B1505A-01A-S

S E R V I C E N O T E

B1505A Power Device Analyzer/Curve Tracer Mainframe

POSSIBLE SHOCK HAZARD

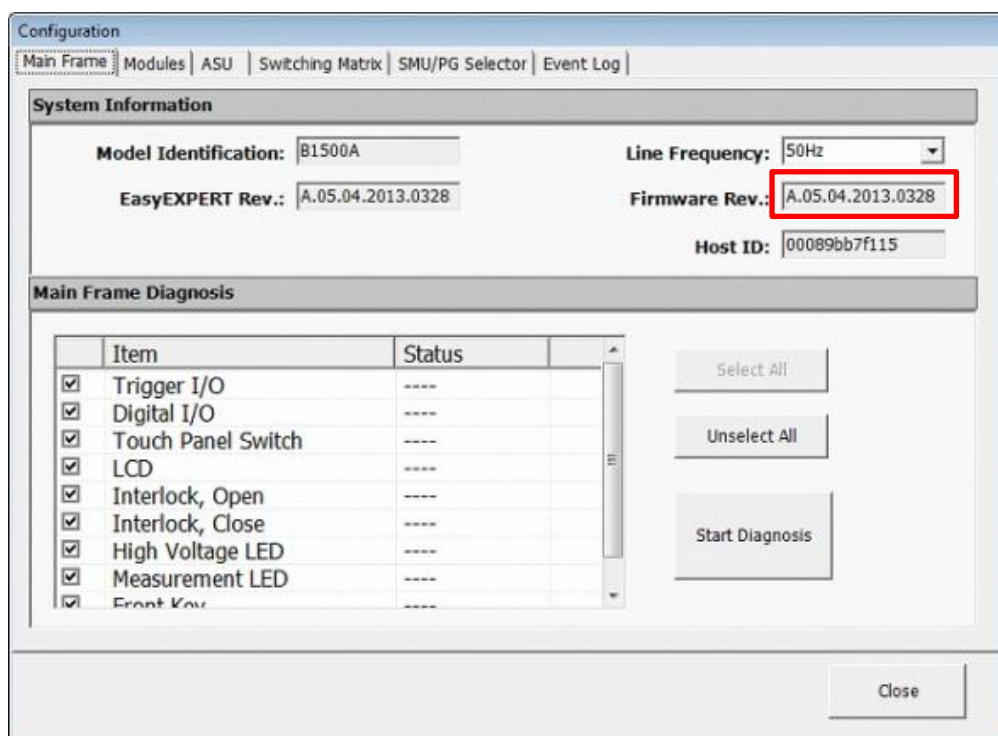
(b) Check the firmware revision of the instrument as follows.

- Start EasyEXPERT and go to “Configuration” window.
- Check the firmware revision displayed in the “Firmware Rev.:" section.
(indicated by ‘red’ square in the screenshot below.)

If the revision displayed is A.05.03 or earlier, proceed to the next step.

If the revision displayed is A.05.04 or later, then this Service Note does not apply.
